Submissions Report

New Education Campus at 207 Barry Way,
Jindabyne

SSD-15788005

On behalf of
NSW Department of Education
June 2022

Figure 1 – Additional Trees to be retained

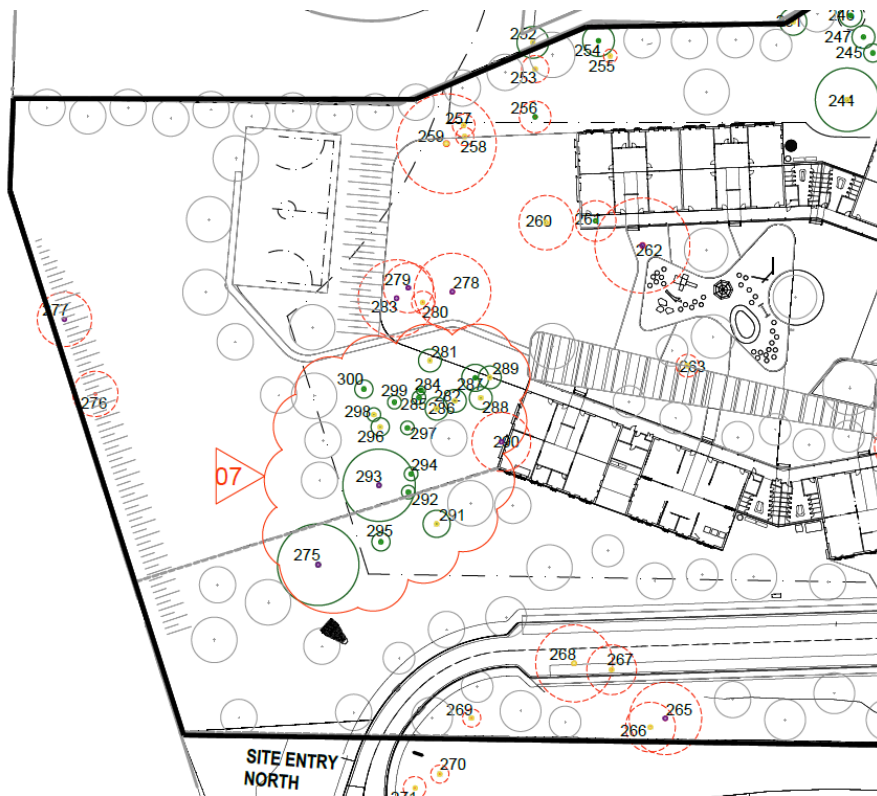
Design refinement	Reason										
Additional Tree Retention	<p>Following comments from Government Architect (refer to section 5.6) and BCD (refer to section 5.1), the proposal has been modified with an aim to reduce the number of trees required for removal. Following design refinement, the proposal has been able to retain a further 19 existing trees that were originally identified to be removed. These trees are located to the north of the site and include Snow Gum – Candle Bark woodland and are identified by the following tree numbers: 275, 281, 282, 284- 289, 291-300.</p> <p>A summary of the changes comparing the original submission and the design refinement is provided below.</p>

Summary of issue/comment	Response
<p>Trees</p> <p>Tree removal levels are excessive. Provide further justification for removal of significant trees and increase tree retention rates, especially larger canopy trees.</p> <p>Significant tree at the main entry should be retained not replaced (adjacent yarning circle).</p> <p>Confirm size of all new tree stock at time of planting.</p>	<p>As identified in Section 3.2 Design refinements, the proposal seeks to retain an additional 19 trees located within the north of the site.</p>
<p>Fences</p> <p>From the Landscape report:</p> <p><i>While the site shall be secured, fencing location and style shall be carefully considered to blend into the landscape, avoiding an institutional or 'fenced in' aesthetic.</i></p> <p>Fence types indicated on p29 of the design report do not support this objective.</p> <p>Provide greater detail on how the proposed fencing and landscape treatments will work together to deliver the stated aim.</p> <p>Fencing along the main façade of the school should be designed to be consistent with the school buildings, not standard black palisade as indicated.</p> <p>Provide drawings at greater detail to demonstrate.</p>	<p>Additional Consultation has been held with the Office of Sport to discuss the Fencing Types to the site.</p> <p>The adjusted fencing strategy has been developed and is included in Appendix 10. The adjusted fencing strategy includes the following changes:</p> <ul style="list-style-type: none"> • Extension of the existing post and rail fencing along Barry way • Moving the secure fence line back from Barry Way in line with the proposed building structure. • The Black Palisade fencing has been modified to a more suitable fencing that will also address the local wildlife issues (i.e. Kangaroos) <p>For further details, refer to the updated fencing strategy in Appendix 10.</p>

<p>Refer to Figure 1 below.</p>			Original Submission	Revised Submission	Retain	76	95 (+ 19 trees)	Remove	134	115 (- 19 trees)
	Original Submission	Revised Submission									
Retain	76	95 (+ 19 trees)									
Remove	134	115 (- 19 trees)
